CLARIFICATION NO. 3

9th February 2026

| Project Name: Major Peebles Wing Clinics' Lobby Renovations | Tender No: RDA/ITT/2026/012/NCB |
| Tender Name: Major Peebles Wing Clinics' Lobby Renovations | |

| | SCALE = 1/8" = 1'-0" | DATE: OCT 2021 | DATE: | MEP08 |

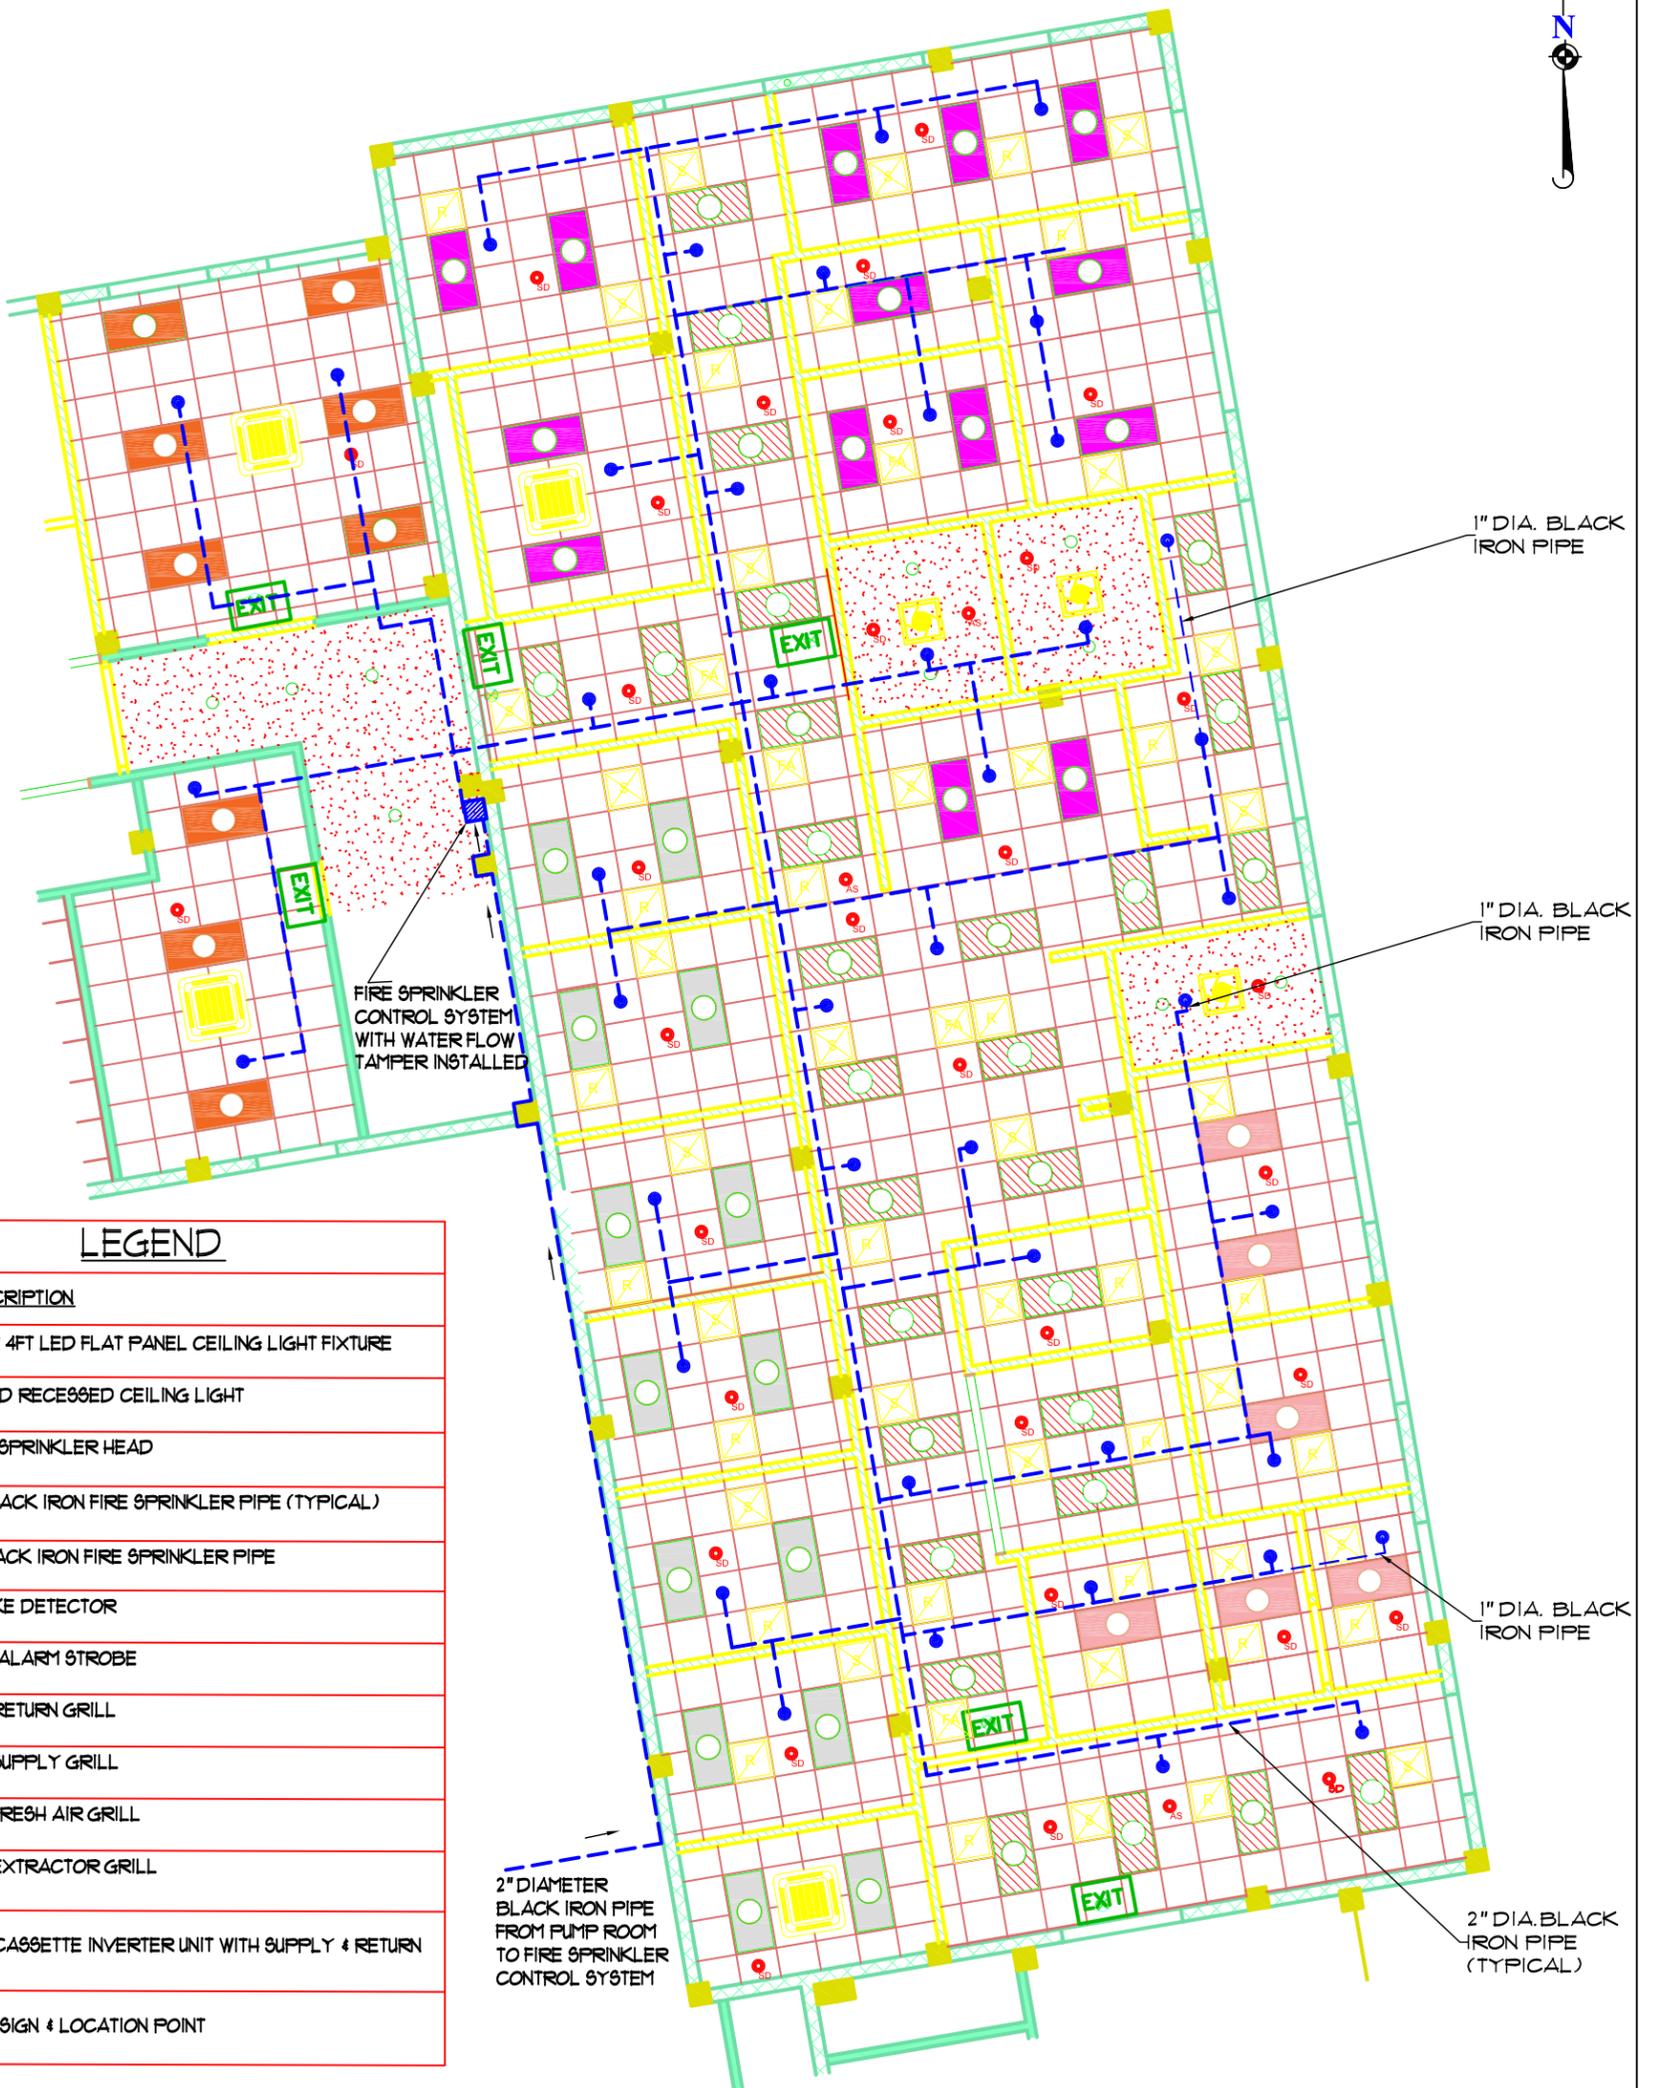
| # | Question | Answer |
|---|--|---|
| 5 | Location of main fire water line | See attachment – Fire sprinkler and MEP drawings |
